SIL 15-WT-01, Rev. A
January, 2017
Page 1 of 3

SUBJECT: Reduced Clearance Planetary Spindles and Spindle Retaining Rings

MODELS AFFECTED: All MD 3000/B 300/B 400/3000 MH

Figure 1. Drilled Hole in Spindle

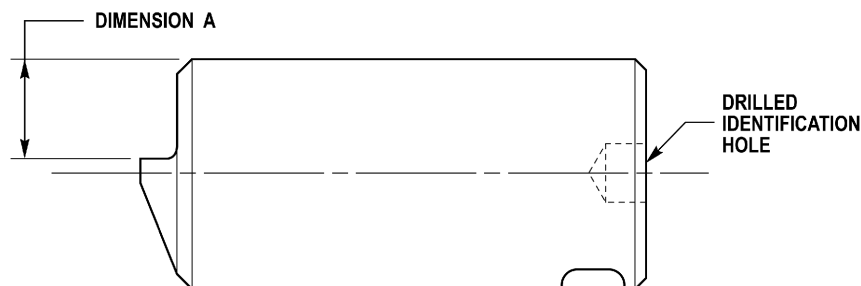
Update 2017: The drilled hole identification in the planetary spindle as described in [Figure 1](#) is no longer necessary. The drilled hole identification has been removed. The planetary spindle part numbers remain the same and there are no changes to the spindle retaining ring.

Current planetary spindles can be identified by a shallow drilled hole in the end of the spindle (refer to [Figure 1](#)). Current P1, P2, and P3 planetary spindle retainer can be identified by a star stamped on the face of the retainer (refer to [Figure 2](#)).

Update 2017: In transmissions manufactured on or after October 2016, the drilled identification hole has been removed from all planetary spindle part numbers shown (refer to [Figure 1](#)). All affected part numbers are forward and backward compatible. Drilled and un-drilled spindles may be mixed randomly within each planetary assembly.
